Proposed Bridge Improvement Project

HUNTINGTON BF 0211(32)

Abutments & Approach Slabs on FAS Route 0211 Bridge #8

CONTRACTORS VISPE:	LEGEND: (A) Oxford A750-7 (D) 3" Pipe (G) 3" x 24" Plastic Corrugated Sleeve (B) P52:20T x 10" Lift (E) 24" Galv. Corrugated Steel Pipe (H) P53 Lift w/ Tension Bar (C) 4" Pipe (F) 15" Galv. Corrugated Steel Pipe (I) 1" Chamfer	PRECAST CONCRETE ABUTMENT SHOP DRAWINGS (SDI JOB #18544) SUPERVISOR: E. Barendse DETAILER: I. ADAMS CHECKER: E. Barendse ENGINEER: CONCRETE ENG. SOLUTIONS	PROJ. NAME: HUNTINGTON PROJECT #: BF 0211(32) LOCATION: HUNTINGTON, VT	INSTALLER: S.D. IRELAND CONCRETE WILLISTON, VT 05495 Ph: (802) 863-6222 04/20/17	FABRICATOR: 193 INDUSTRIAL AVE. WILLISTON, VT 05495 Ph: (802) 863-6222 OVERVIEW	1/29
---------------------------	--	---	--	--	---	------

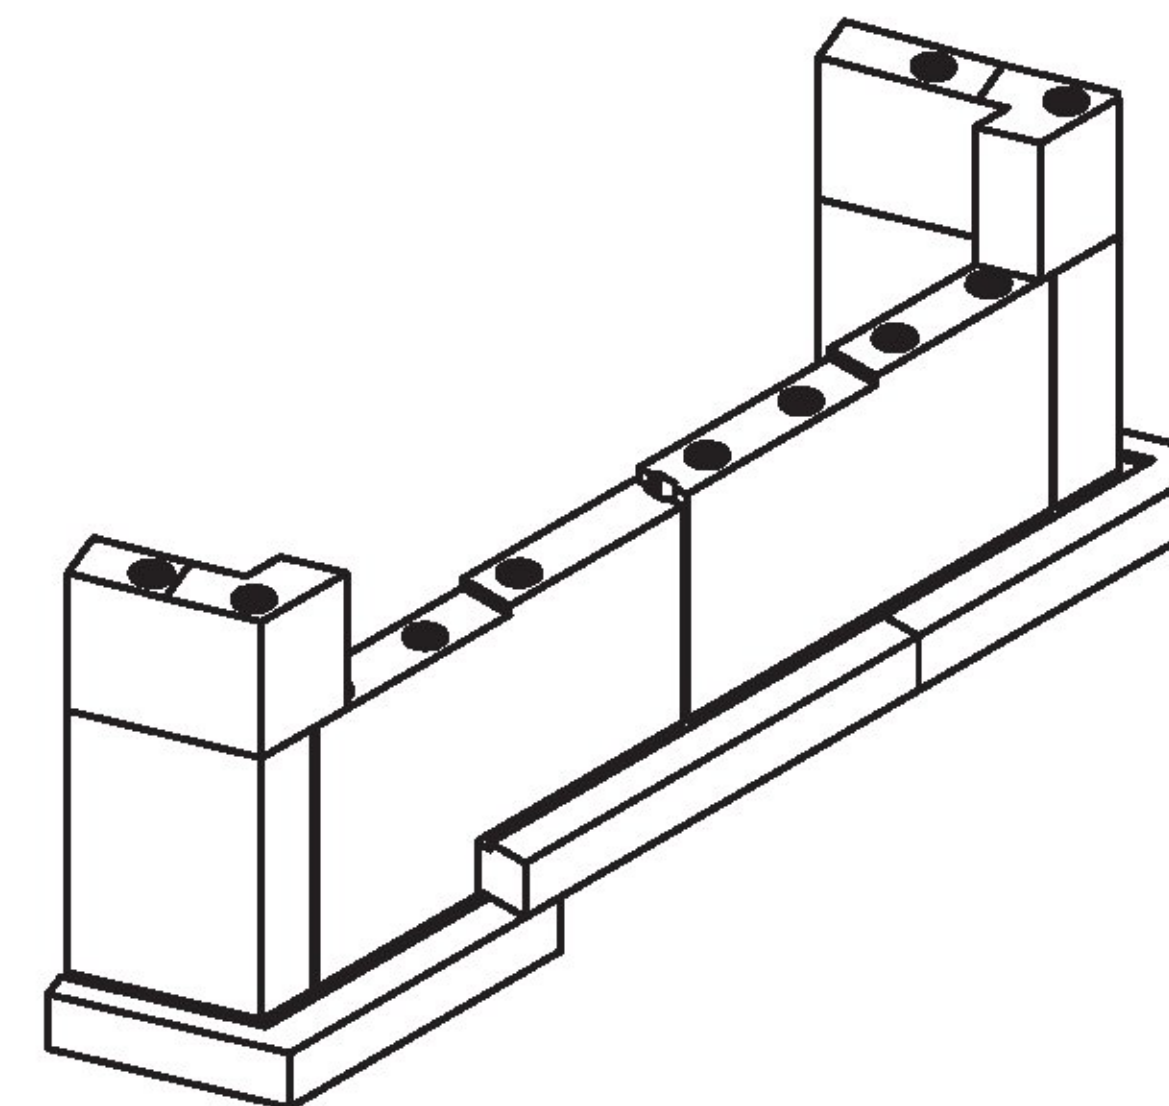
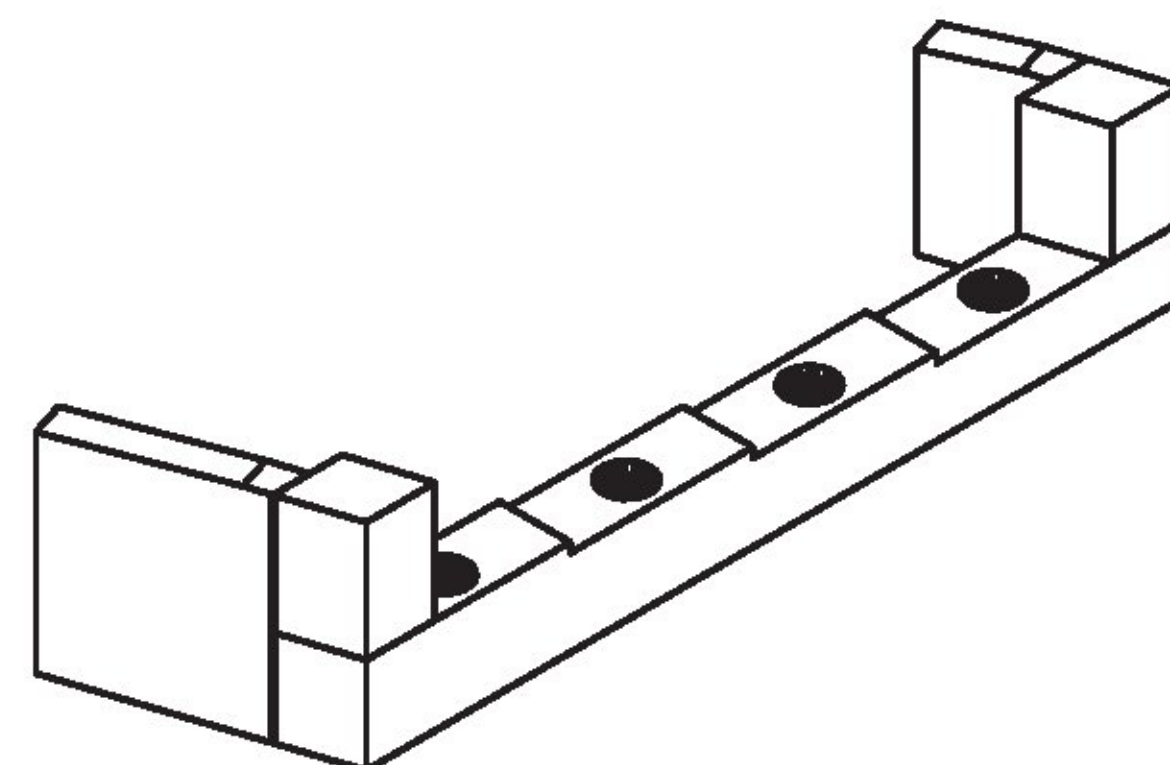
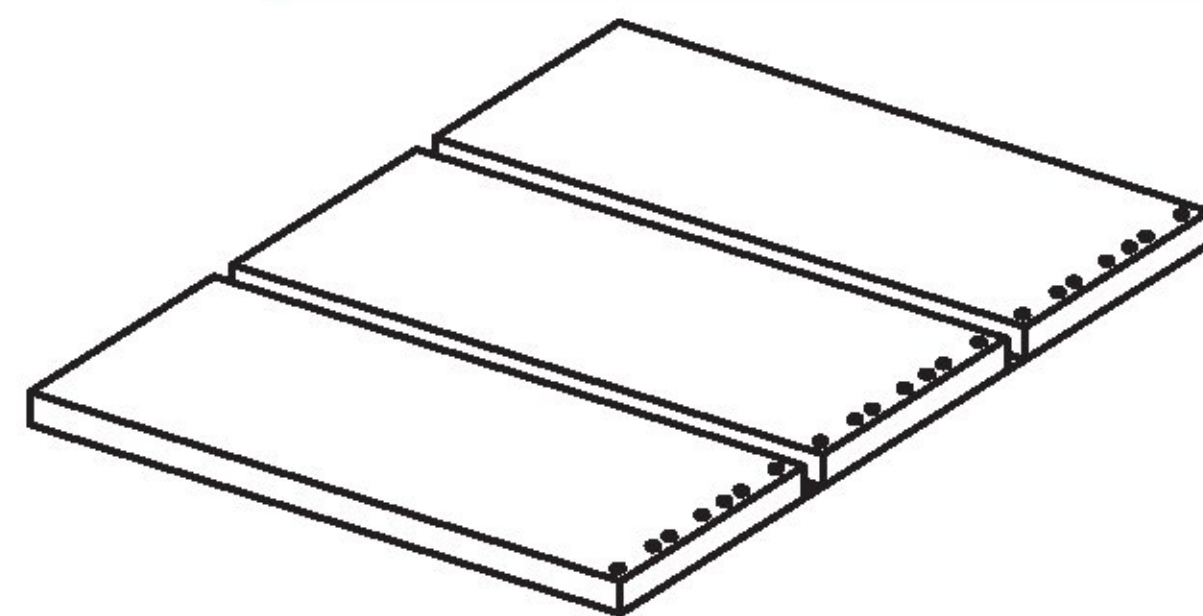
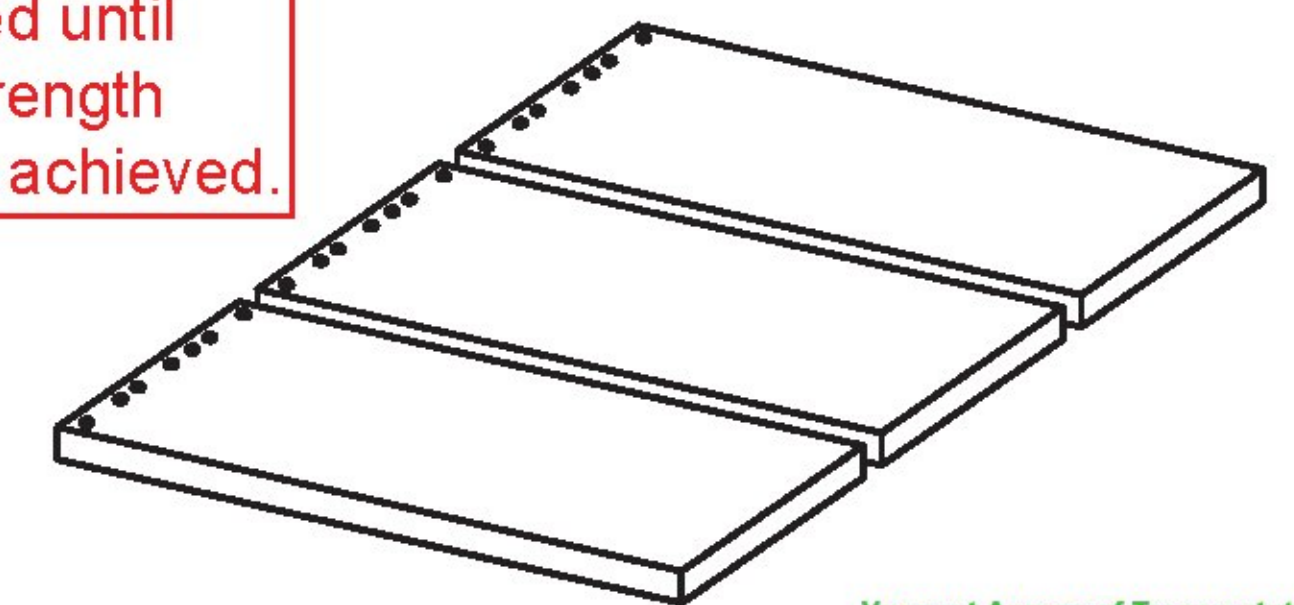
Per email from Matt Wheeler on 4/27/2017 in regards to the horizontal load: Q: "For the installation of Wingwalls 1 & 2, you're planning on applying a horizontal load to join the pieces prior to grouting the splice sleeves and securing in-place with waste blocks. We're interested in the planned method of applying the horizontal load to ensure that this has been considered and will adequately close the joint."
A: "The load will be applied to the wingwalls via come-alongs and or/jacks. Excavation machinery will not be applied to close this joint."

Per 540.08(a)(1), cure shall be maintained until design strength has been achieved.

8. All lift anchors are to be galvanized and will remain in place and grouted by site contractor with VAOT approved material.
9. When installing Wingwall 1 & 2 a horizontal load shall be applied to close the gap between adjoining pieces, and held in place by waste block, throughout grouting and curing process of NMB splice sleeves.

Vermont Agency of Transportation
RECEIVED
CK'D BY _____ OK'D BY Rob Young
April 21, 2017
RESUBMIT NO _____ Approved AsNoted
BY Rob Young DATE 04/28/2017
